APPLICATION NO.	FILING DATE	FIRST NAMED INVENTOR	ATTORNEY DOCKET NO.	CONFIRMATION NO.
10/821,065	04/08/2004	William Gordon	GOR101	9201

Office Action Summary

GORDON, WILLIAM

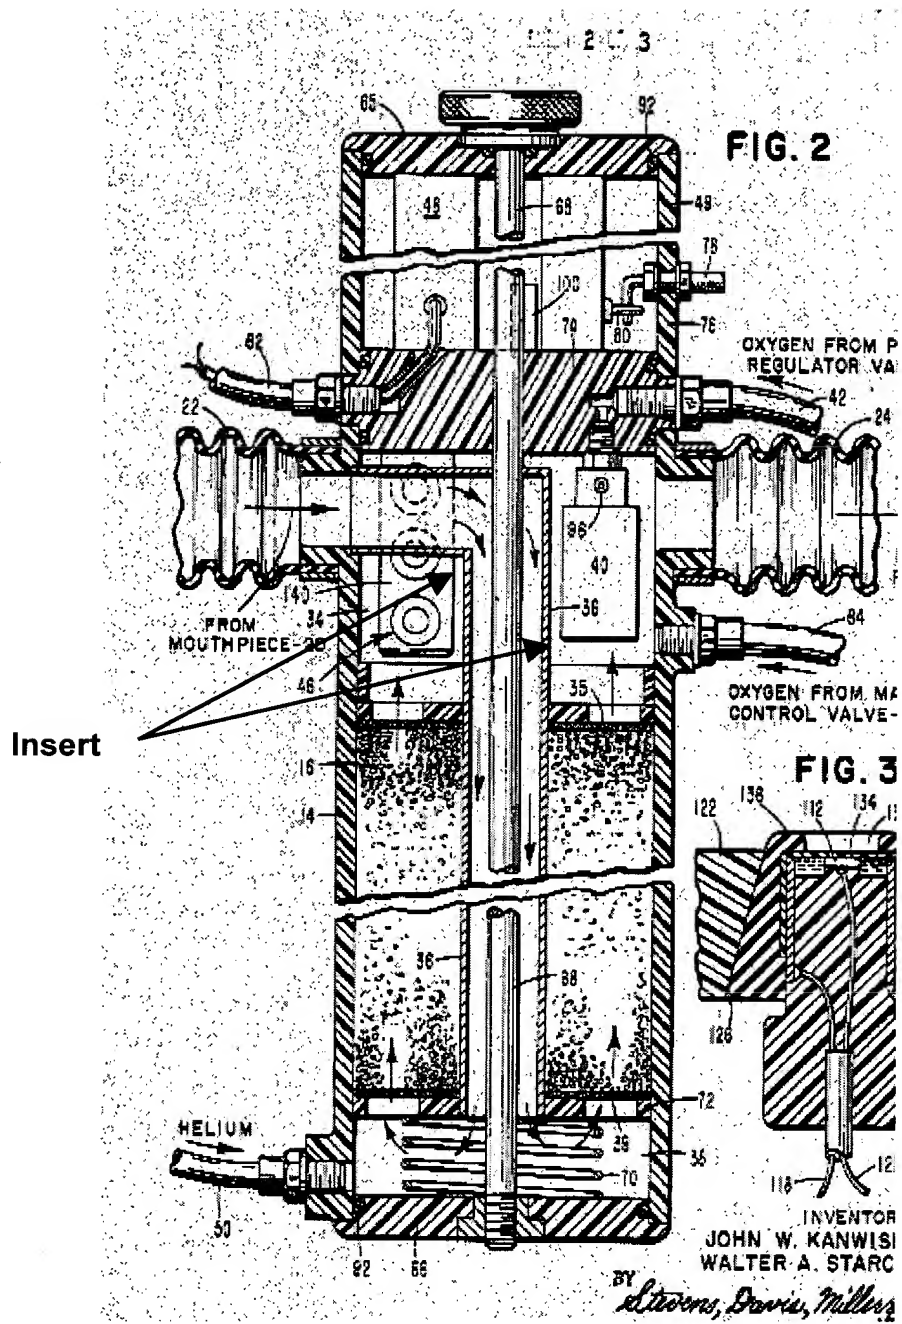
Regarding claim 9, Kanwisher discloses wherein the apparatus is configured such that the gas scrubber canister (14) is worn on a divers back (Fig. 1).

Regarding claim 10, Kanwisher discloses wherein the long axis of the canister (14) is parallel with the long axis of the diver's body (Figs. 1, 2).

Regarding claim 11, Kanwisher is configured such that that gas scrubber canister (14) can be worn on the front of a diver's body (Figs. 1, 2).
